Addendum No. 1
Page 1 of 2

TO: Prospective Bidders
SUBJECT: Addendum No. 1
PROJECT NAME: Romeoville B Entrance Canopy
JJC PROJECT NO.: B20016

1. Drawing A-101, PARTIAL FLOOR PLAN, ELEVATIONS, SECTIONS AND DETAILS (Drawing revision dated 2/4/2020 is included with this addendum.)
 - a. Drawing 5/A-101, titled, ELEVATION - B.

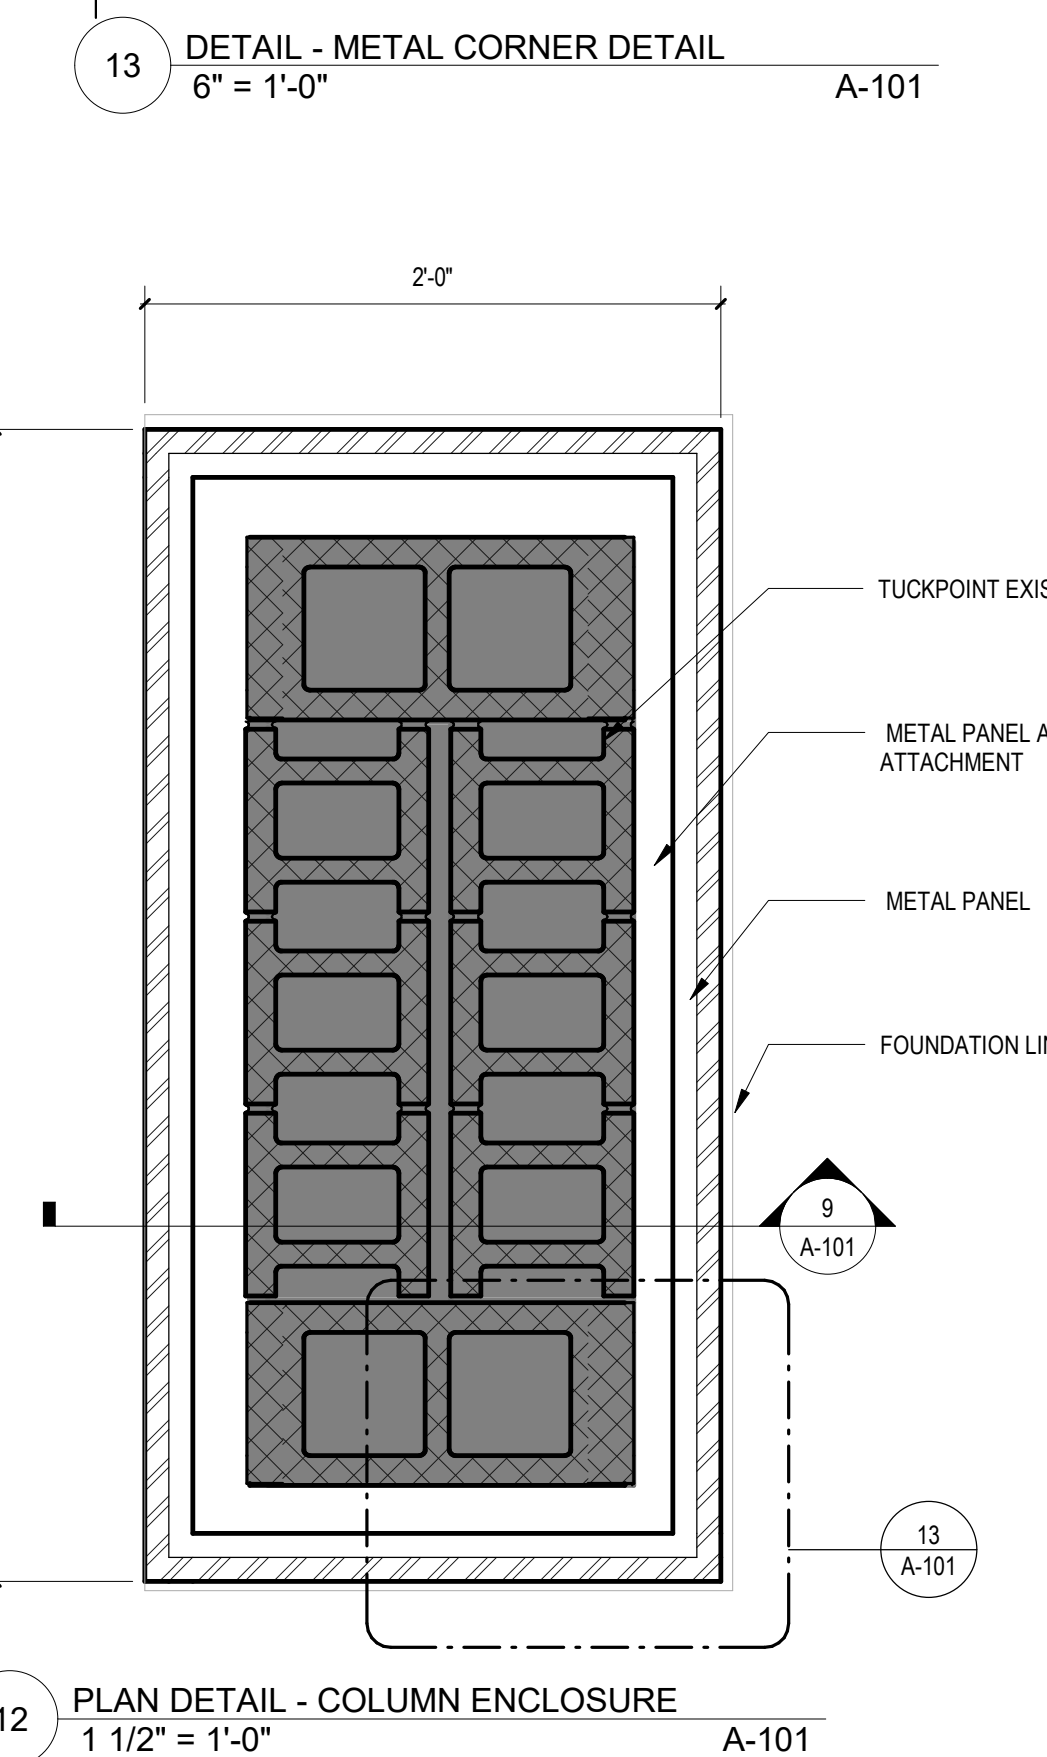
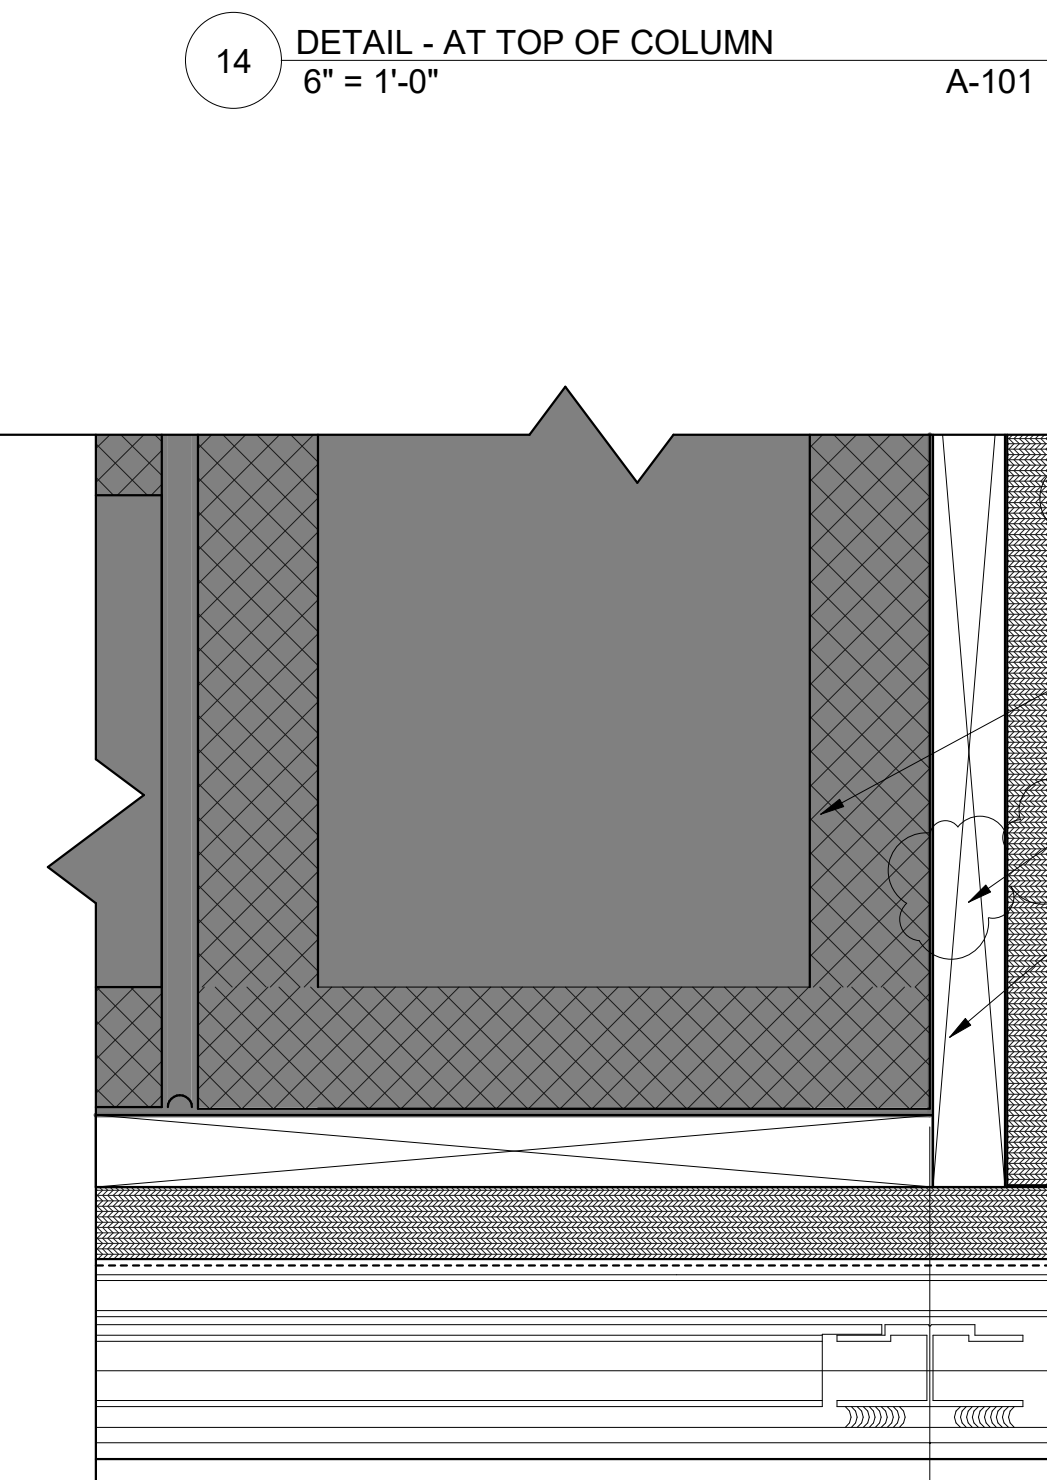
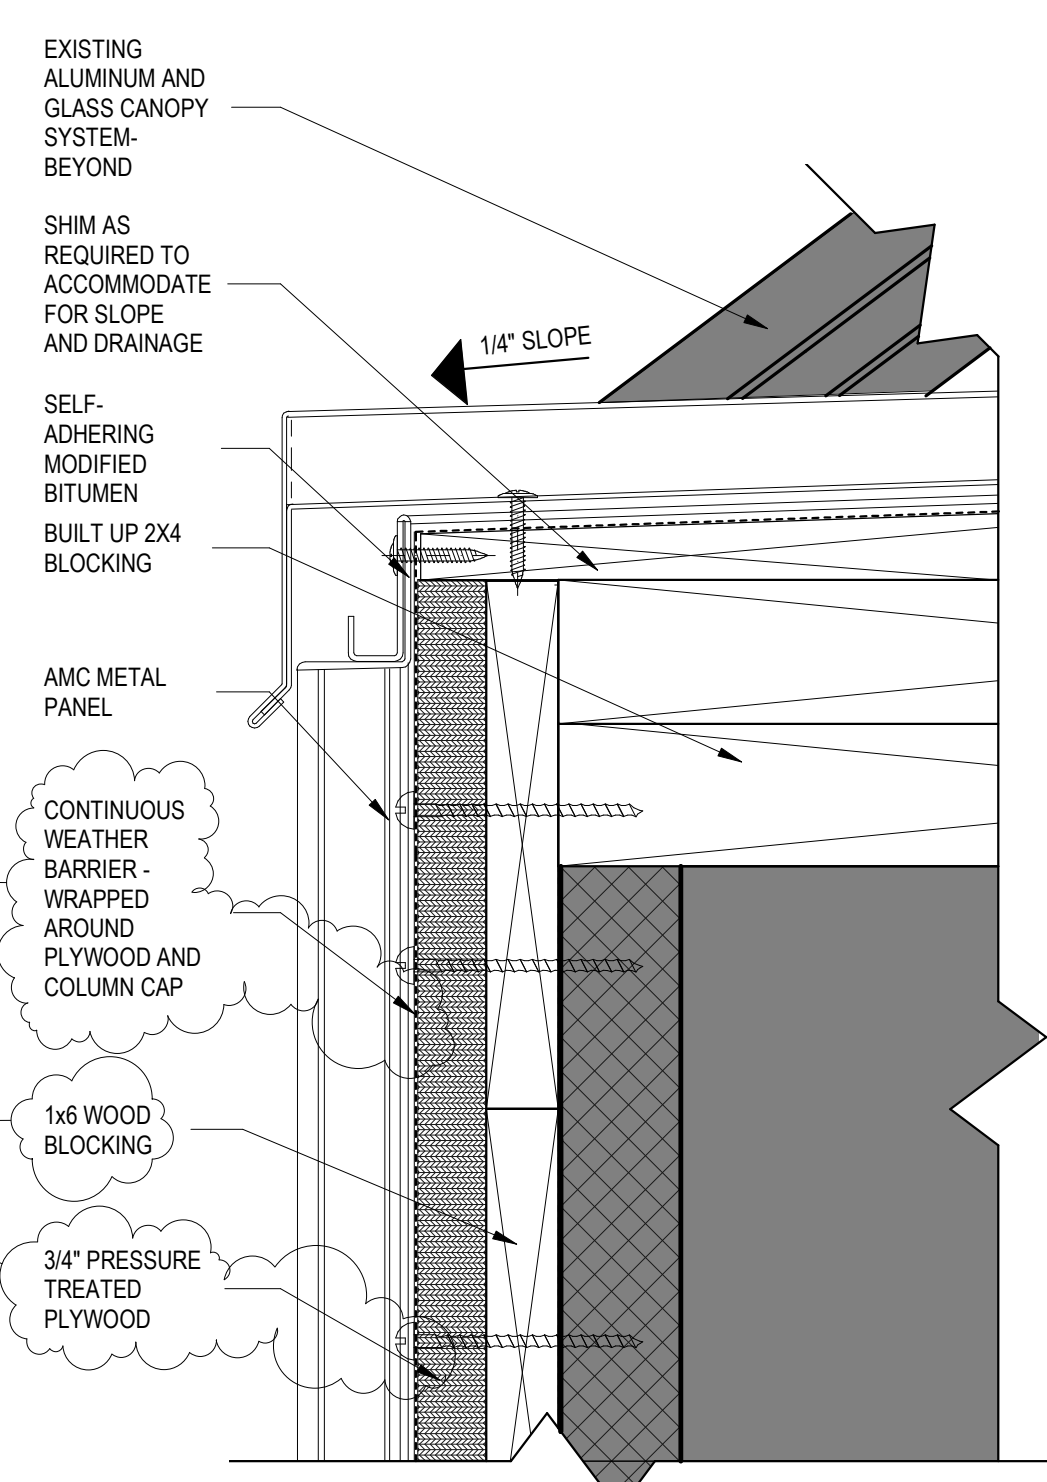
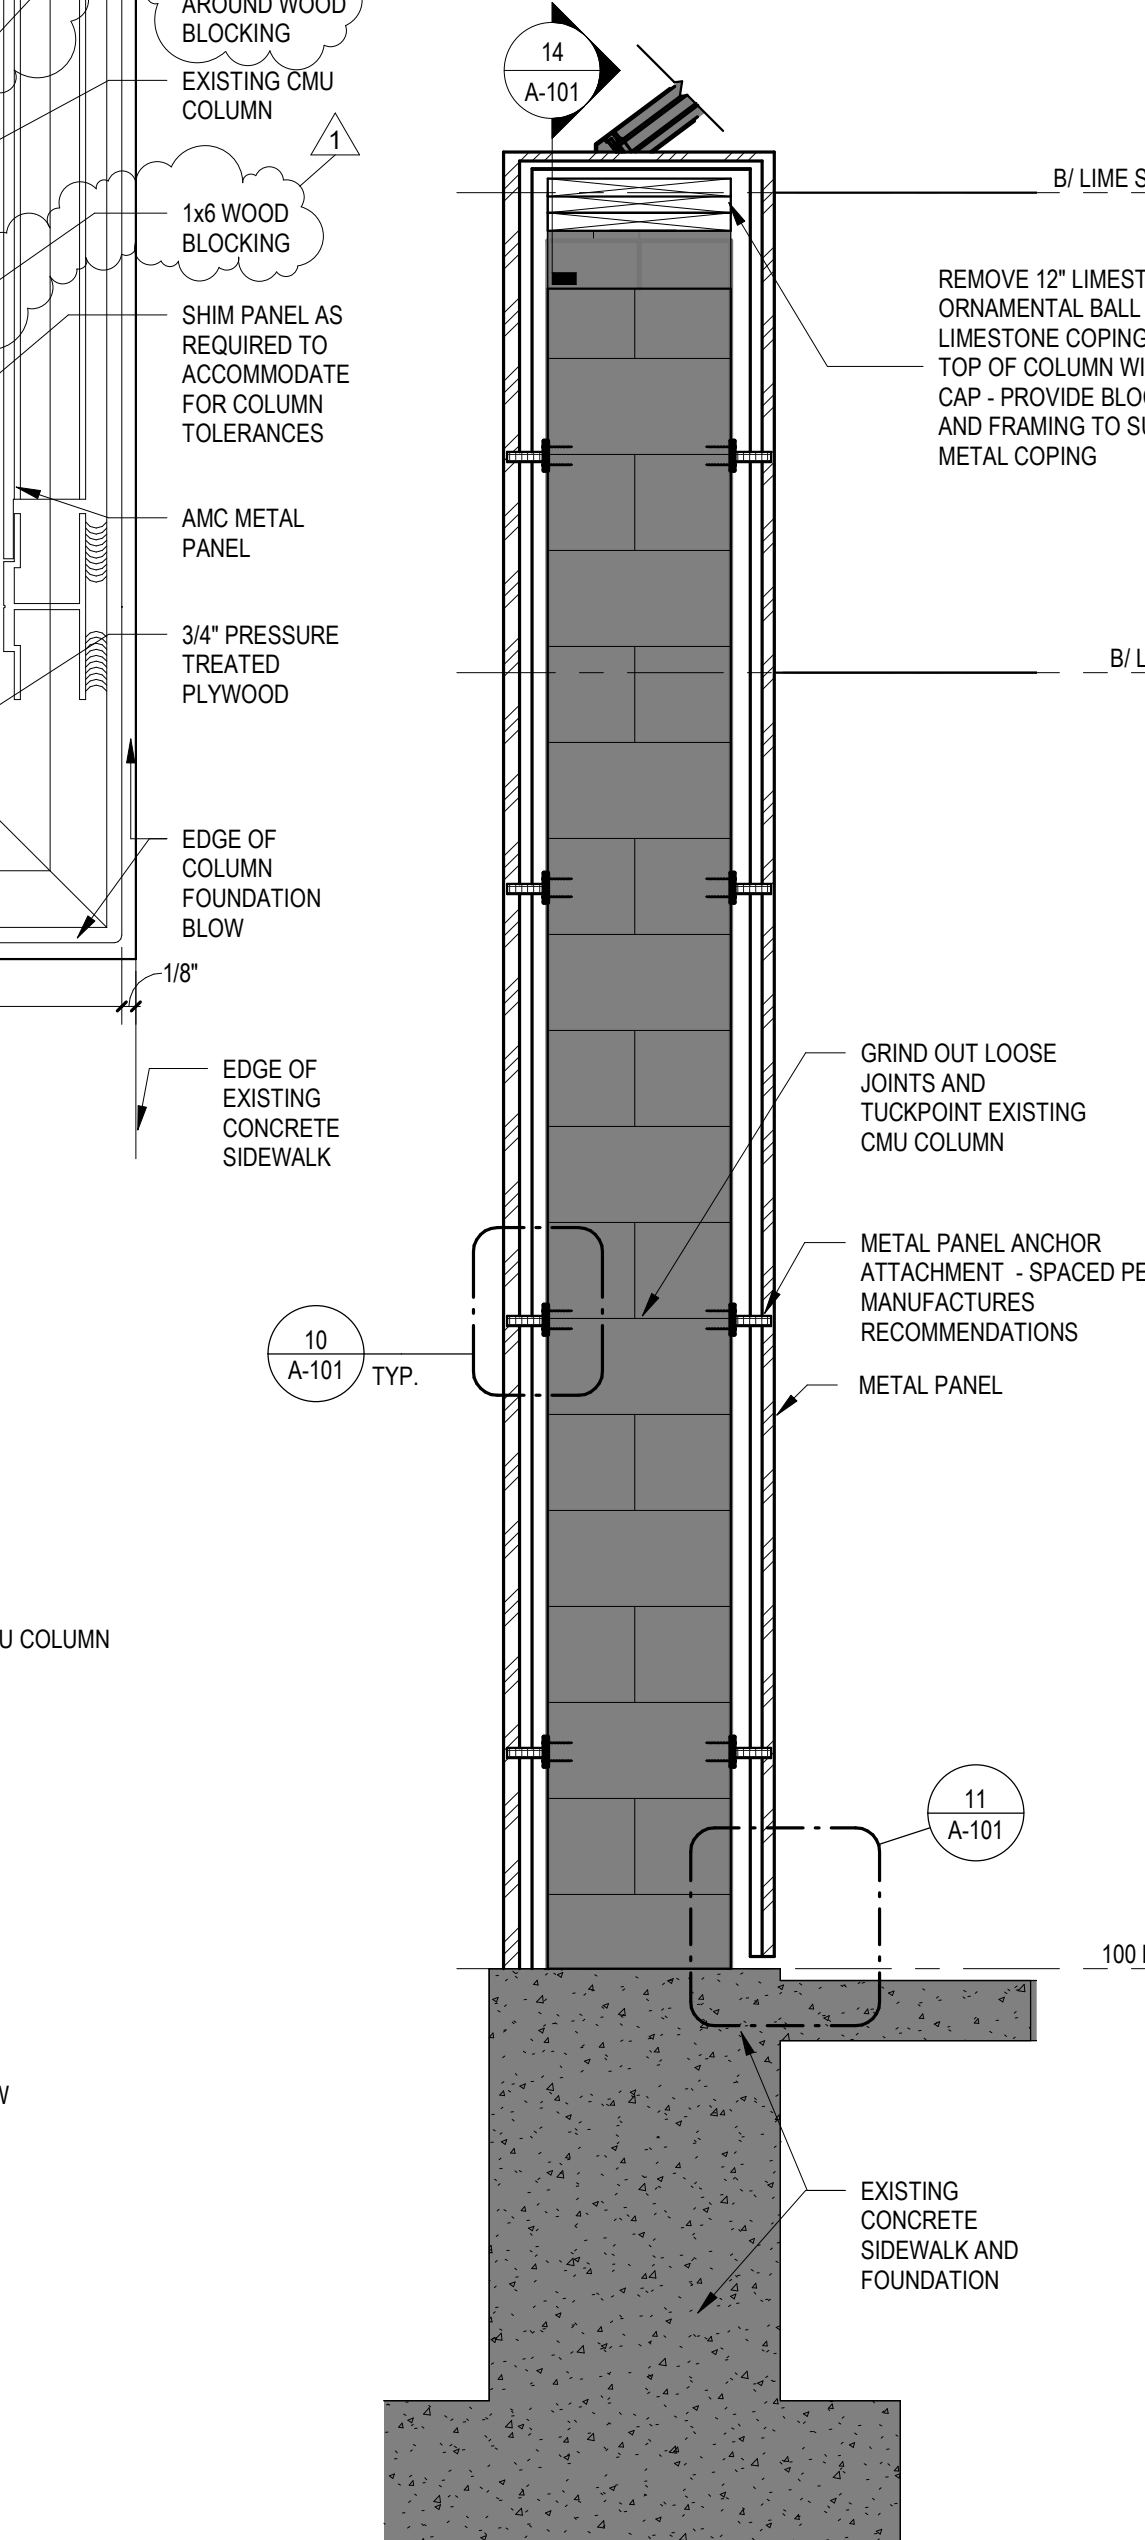
1. INCREASE HEIGHT OF AMC PANEL ABOVE STOREFRONT ENTRANCE:
 - a. REVISE HEIGHT OF AMC PANEL TO 3'-4".
 2. Details 10/A-101 & 11/A-101 & 14/A-101 & 17/A-101 & 18A-101, titled correspondingly, DETAIL - METAL PANEL CONNECTION & DETAIL - METAL PANEL CONNECTION AT BASE & DETAIL - AT TOP OF COLUMN & DETAIL - FLASHING AT TOP OF CANOPY & DETAIL - FLASHING AT TOP OF CANOPY
